**Re: Agnico Eagle's Comments on the 2021 Draft Nunavut Land Use Plan and 2021 Options and Recommendations**

**Appendix A: Agnico Eagle Review Comments to 2021 DNLUP and 2021 O&R**

<b>To</b>	Jamie Quesnel; Agnico Eagle
<b>From</b>	Dr. Greg Sharam; ERM
<b>Date</b>	6 October 2021
<b>Reference</b>	0614866-01
<b>Subject</b>	High-Level Review of the 2021 Draft Nunavut Land Use Plan.

**Agnico Eagle Mineral Rights, Prospection Permits, and Land Use Designations in the 2021 Draft Nunavut Land Use Plan**

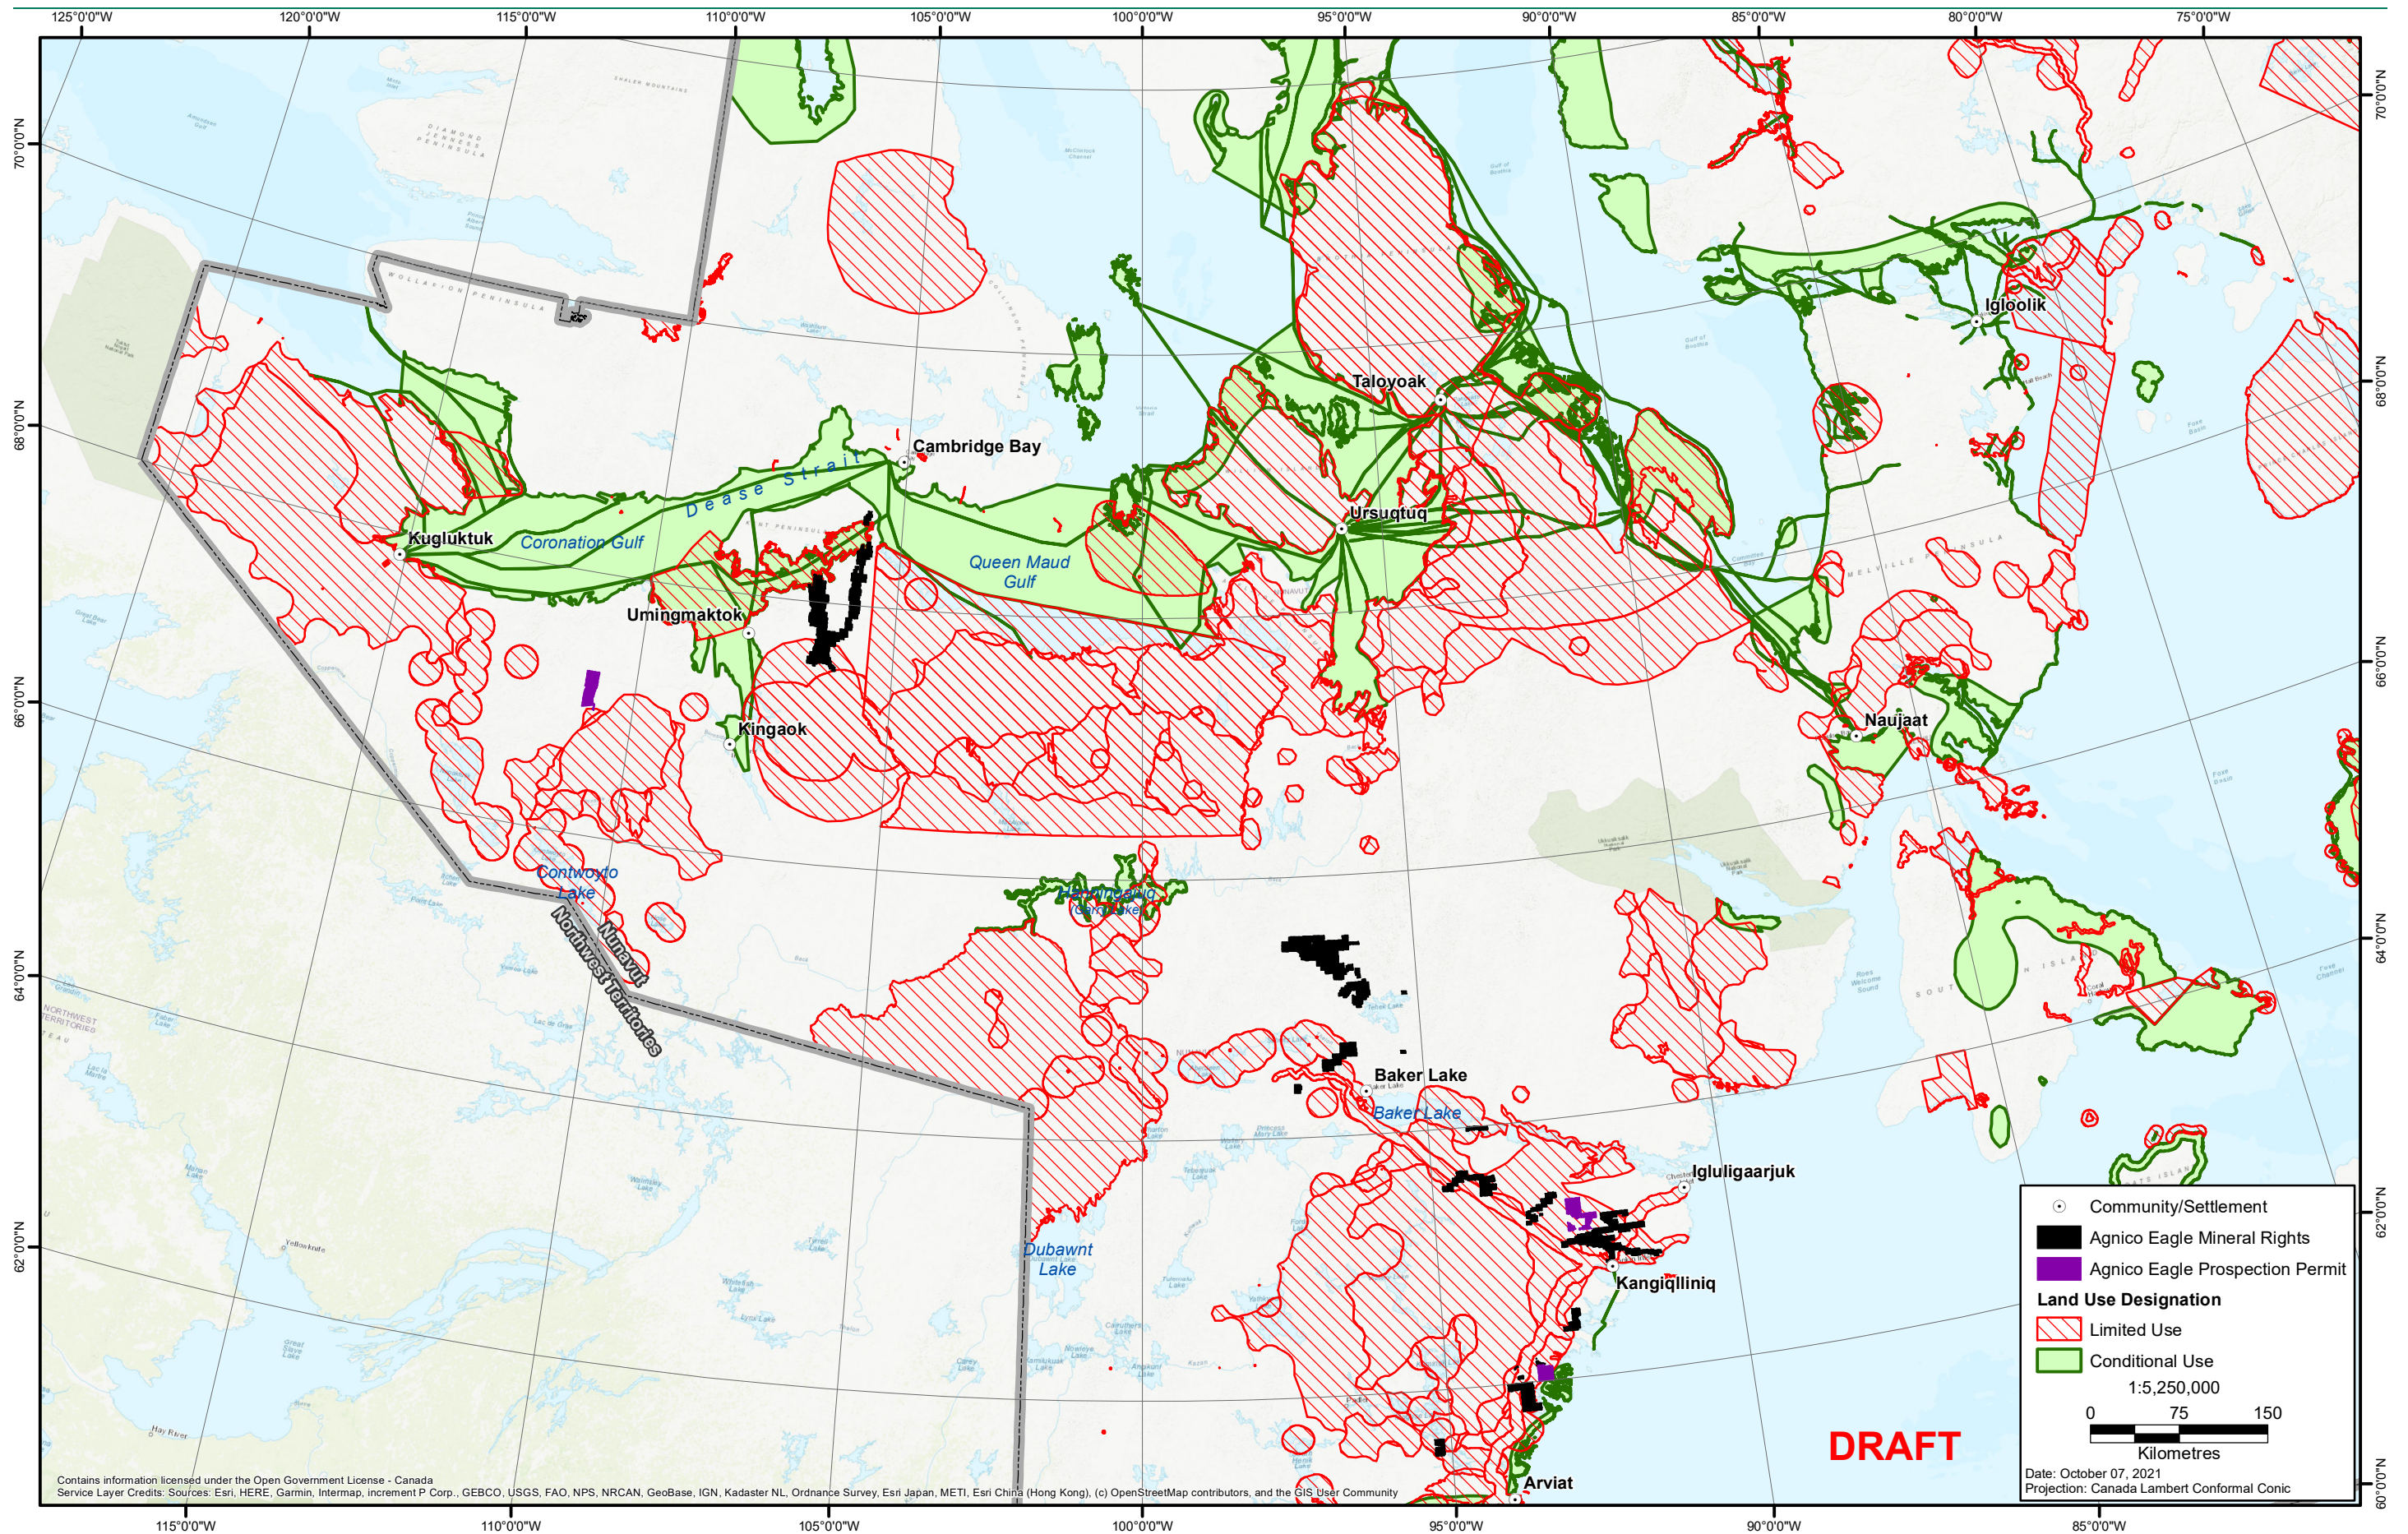
- **Appendix A Existing Rights and Map B2.13 require revision to ensure both are complete and accurate.**

We note that not all of Agnico Eagle’s existing rights are reflected at Appendix A Existing Rights. The enclosed updated map (Figure 1) reflects our current existing rights. We have reviewed map B2.13 “Existing and Potential Linear Infrastructure”. We note existing infrastructure to the Meliadine Mine is not

recognized on the map, through it appears that existing infrastructure from Baker Lake to Meadowbank is generally reflected.

Overall, we suggest that all existing claims (land tenures) that are grandparented should be included on a map that highlights all land tenures, that is attached to the NLUP for reference purposes. There should be no overlap of polygons that restrict the grandparented claims.

In addition, the date of eligible grandparented claims should be adjusted from April 2021 to the date when the DNLUP is approved and comes into force. Tenures which do not appear on the NLUP map would still be able to get the benefit of grandparenting if they are able to provide evidence their tenure was valid as of the date the DNLUP is approved and comes into force.
